EPA Superfund
Record of Decision:

VIENNA TETRACHLOROETHENE
EPA ID: WVD988798401
OU 01
VIENNA, WV
09/27/2002

Vienna PCE Superfund Site Vienna, West Virginia

Figure 3
Round 1 Concentrations of PCE
in Shallow Groundwater Samples
February 2001

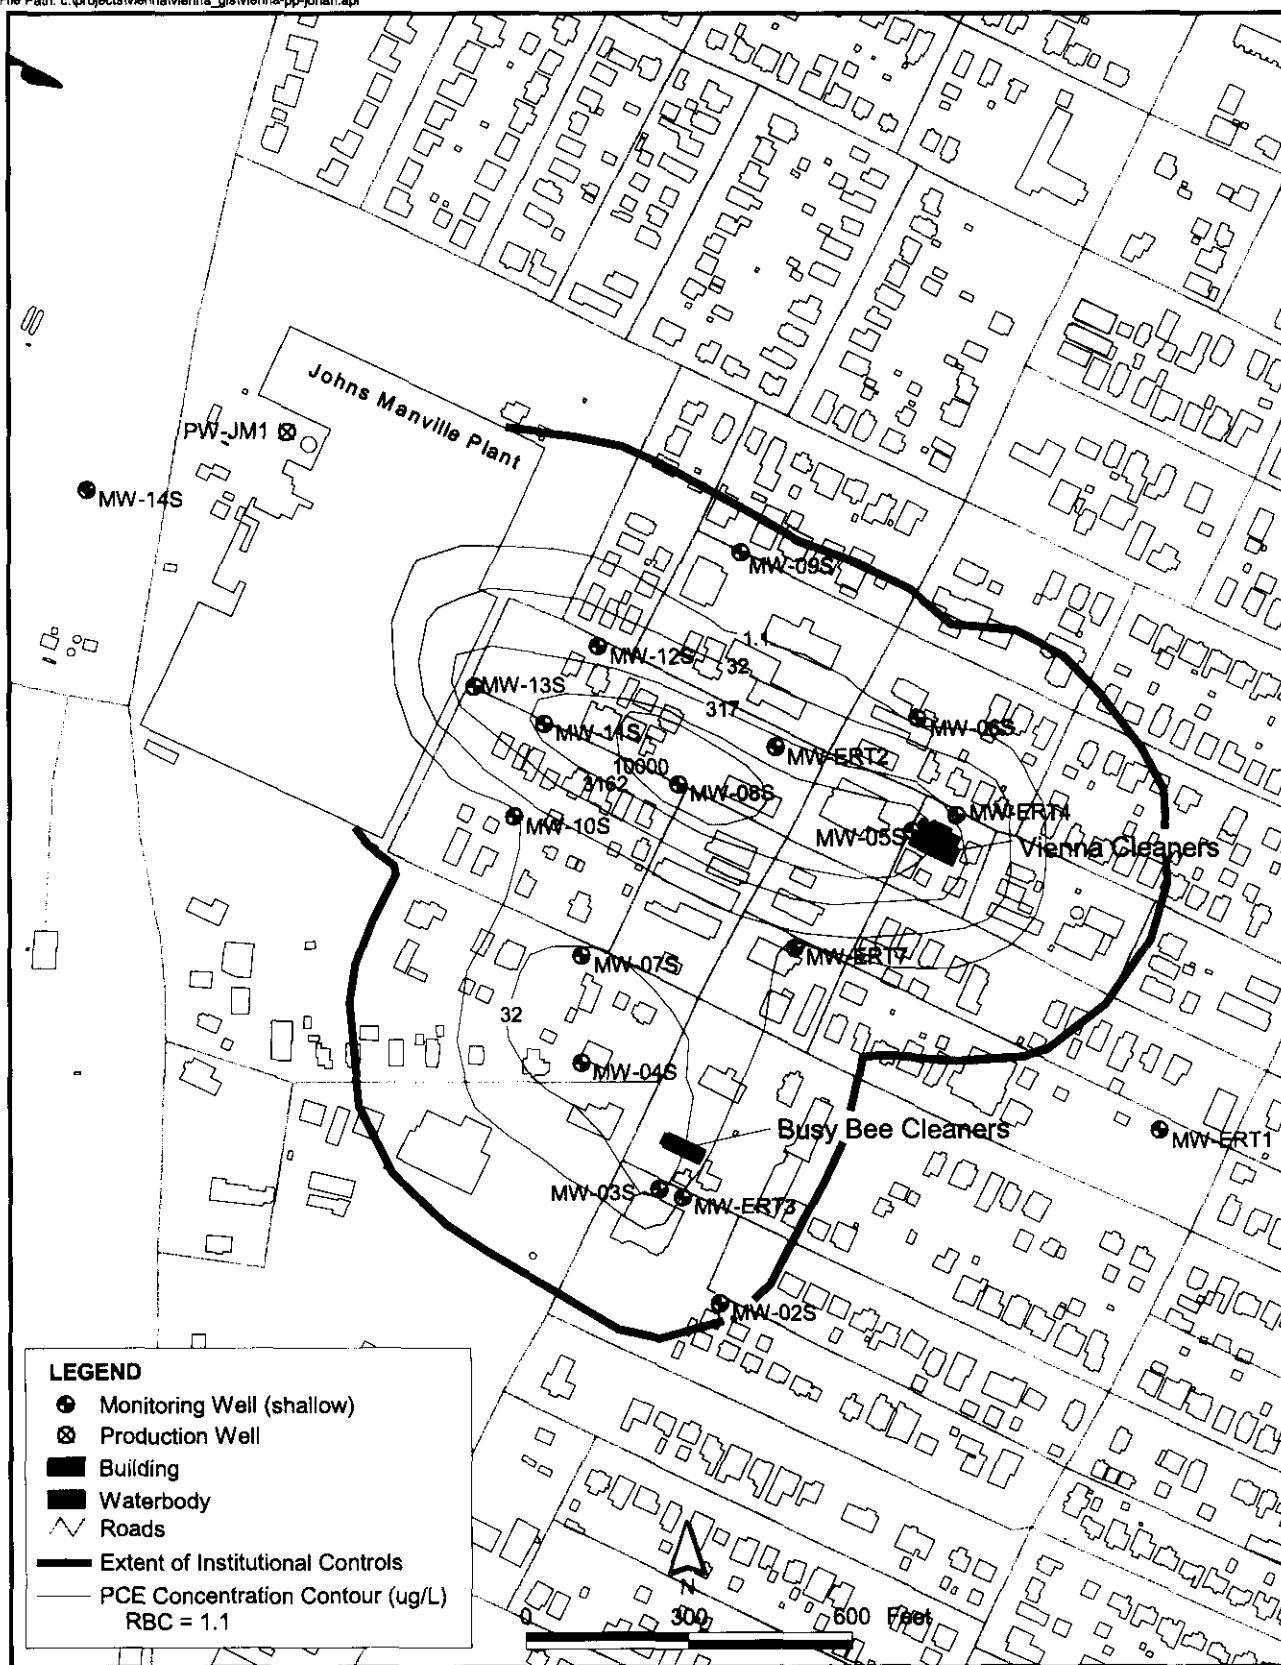
B.17 A citizen wrote: Figure 3 of the Appendix (PCE concentrations, February 2001) shows reasonable coverage by monitoring wells to produce the concentration contours that are inferred, except for the lower concentration contours connecting the smaller Busy Bee Cleaners source across-gradient to the main body of the Vienna Cleaners

plume. Such a connection would seem to require data from another monitoring well, and would also require contaminant movement along, rather than perpendicular to, the potentiometric contours shown on Figure 4.

B.18 A citizen wrote: The significant message of Figure 3, however, is that the highest concentrations of PCE have only moved about three blocks down 29th street in the 50+ years since the Vienna Cleaners began operating in the late 1940' s. It would appear that the PCE plume would likely not emerge on the west side of the Manville Plant for decades more. Given the additional facts that waste PCE dumping has not occurred for decades, and a "gap" of much cleaner groundwater now exists back upgradient toward the source, a relatively lower-level threat is presented and a correspondingly lower-level remedy (than the current Proposed Remedy) is indicated.

B.20 A citizen wrote: PCE is known to be subject to degradation in groundwater, with EDC and TCE at relatively low levels being typically produced and then degrading. The contouring of the PCE plume (Figure 3) and the relatively clean "gap" back toward the source, where apparently large amounts of PCE are still being recovered from the soil, may imply that degradation is occurring at a finite rate, although it is likely limited by the lack of local dissolved oxygen; much of the area is covered by streets, buildings, homes, driveways, asphalt parking lots, etc so there is probably little local infiltration of oxygenated rainwater. Dissolved oxygen (supporting either hydrolysis or biological degradation of the PCE) is probably low in the center of the plume. Depending on the sampling protocols, dissolved oxygen is sometimes obtained and recorded as a field parameter. I suggest that DO readings be compared for wells both inside and outside the PCE plume; wells 09S, 11S, 08S, and 10S, for example. If an area of low DO is present, then a minimal amount of air sparging, directly in the center of the plume, would be very beneficial.

EPA Response: EPA agrees, as depicted on Figure 3, the plume from the Busy Bee cleaners location does appear to have a more northerly component of flow than the plume from the Vienna Cleaners property. EPA will ensure that additional monitoring points are installed during the Remedial Design to ensure treatment of the smaller plume.

EPA Response: EPA agrees that the plume is migrating at a relatively slow rate of speed. However, the contamination has already migrated approximately 1,500 ft, and has seriously threatened the City of Vienna's water supply. (Six municipal wells have already been taken out of service). Further, there are a number of influences on the plume in its current location that are not present at the Vienna Cleaners area that will accelerate its movement, namely the City of Vienna groundwater production wells. Groundwater modeling studies undertaken by EPA and the USGS indicate that the groundwater plume will accelerate as it draws closer to the City of Vienna production wells. Thus EPA does not believe we should employ a "lower level" remedy to address this problem.

EPA Response: EPA completed a full sampling round of analysis of BOD, COD, DOC and other Natural Attenuation Parameters as detailed in the Remedial Investigation. As a result of this portion of the investigation, EPA concluded that biodegradation of chlorinated hydrocarbons, specifically PCE, in groundwater through reductive dechlorination is not occurring at the Site. However the Selected Remedy will do just as you suggest, as it will supply oxygen via air sparging directly in the center of the plume.
